Subject: Project 12613082, Addendum No. 1, Geotechnical Engineering Report, Route 14 Drainage Improvements, Buckley Hall Road, and Main and Church Streets, Mathews County, Virginia

ROUTE 14 DRAINAGE IMPROVEMENTS
BUCKLEY HALL ROAD, AND MAIN AND
CHURCH STREETS,
MATHEWS COUNTY, VIRGINIA

Figure 3: Bedding Detail

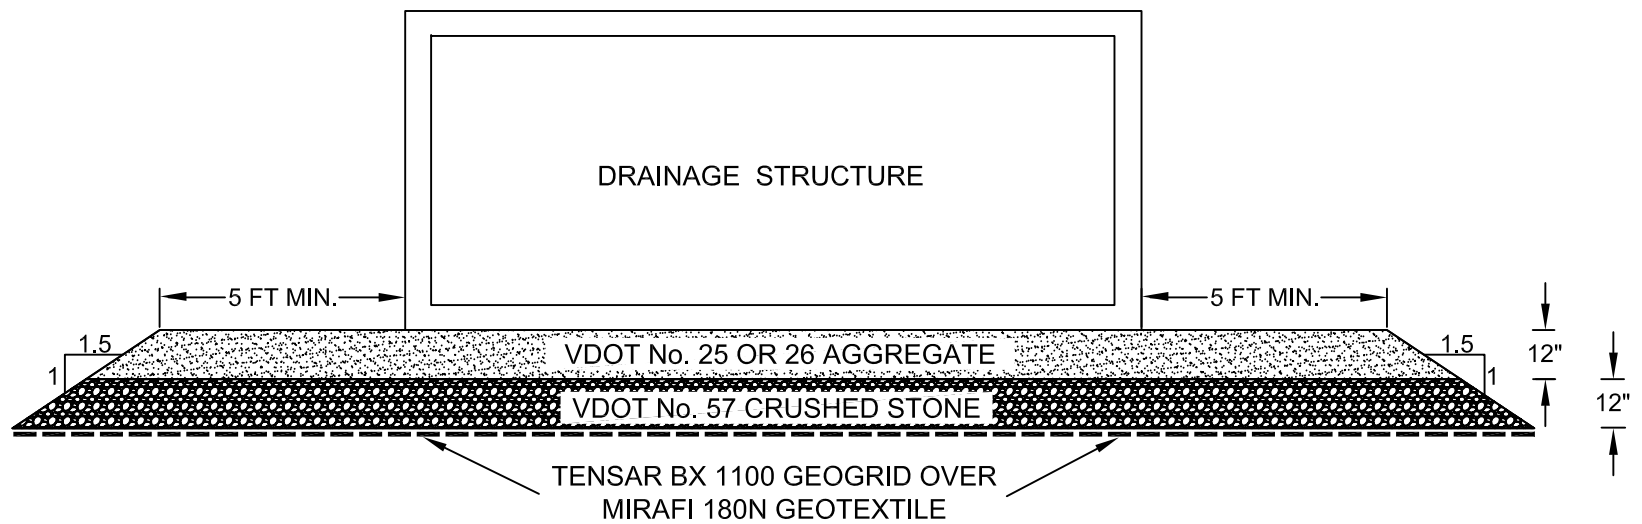
Culverts, HECPs and junction boxes should be installed in accordance with the VDOT Road and Bridge Specifications (2007) and subsequent addenda. In order to reduce potential recompression settlement, we recommend supporting these structures on a mat of crushed stone reinforced with geogrid. The crushed stone mat should be at least 2 ft thick, and should consist of 12 inches of VDOT No. 25 or 26 aggregate over at least 12 inches of VDOT No. 57 crushed stone.

The VDOT No. 57 crushed stone should be underlain by a layer of drainage geotextile placed directly on the subgrade, and a layer of geogrid placed directly on the drainage geotextile. The crushed stone mat should extend at least 5 ft beyond the limits of the drainage structures as illustrated on attached Figure 3, Bedding Detail. The crushed stone mat should be uniformly compacted in place.
